Service Bulletin

Subject: Possible Oil Leak On Gen 5 Engine After The Harmonic Balancer Is Removed Or Replaced

Models: 2014 Chevrolet Corvette
2014 Chevrolet Silverado 1500
2014 GMC Sierra 1500
Built with RPOs 4.3L 5.3L 6.2L L83 L86 LT1 LV3

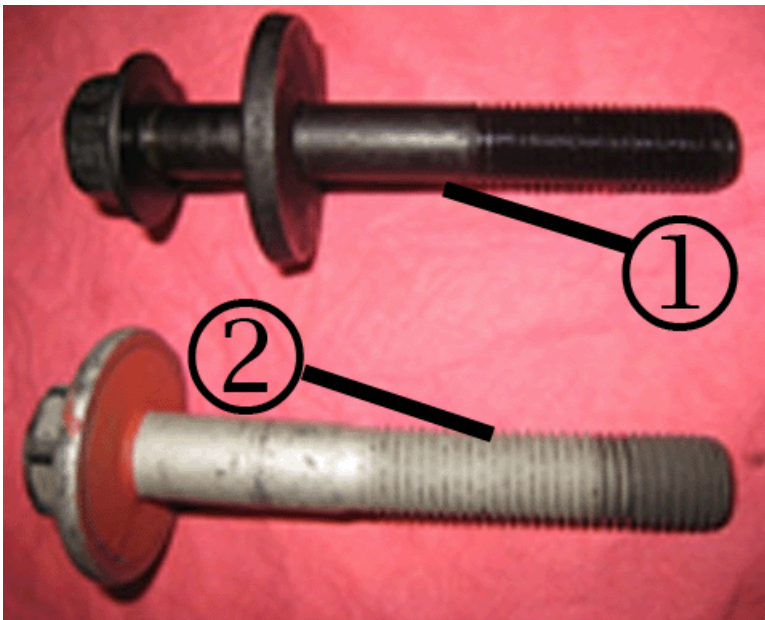
- Gen 4 engines use a non-keyed Harmonic balancer. The only part of the crank that is keyed drives the oil pump. The bolt has a friction material on the face. It does not seal the Harmonic Balancer to the crank.
- Gen 5 engines use a keyed Harmonic Balancer that can see oil pressure. It uses a two piece bolt and washer arrangement. It does seal to the face of the crank.

Note: If you use a Gen 4 bolt in a Gen5 engine you will have an oil leak.

1- is for a gen 5 engine

2- is for a gen 4 engine
